TECHNICAL BULLETIN

October 2025

i30 Gear Motor Protection Update: Firmware & PCB Upgrade

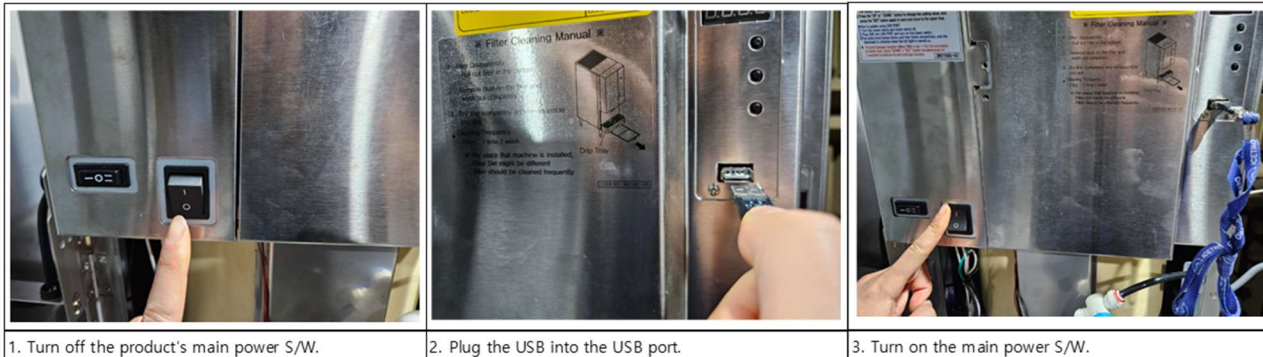
Cause:

Small and brief power dips cause the unit to shut down the gear motor, but the compressor continues to rapidly cool the ice-making auger. The water in the auger quickly freezes and moments later, when the power level normalizes, the gear motor attempts to engage, but the auger is 80-90% frozen. The torque output against the auger **causes damage to the plastic gear in the motor.**

In addition to replacing a damaged gear motor, an updated PCB and FND update must be installed that prevents this situation entirely. The update ensures both the auger and gear motor shut down simultaneously during power dips, avoiding freeze-up and gear damage. Updated main PCBs are supplied with a memory stick to update the FND PCB. **Updated PCBs must have the FND PCB updated as well; mismatched firmware versions are not compatible.** If a replacement gear motor is installed, the PCB/firmware update must also be installed to prevent repeat failures.

1. Replace damaged gear motor *and* install new updated PCB (includes new firmware).
2. Use the provided memory stick and supplied instructions to update the FND PCB firmware.
3. Verify that both updates are complete to prevent repeat failures.
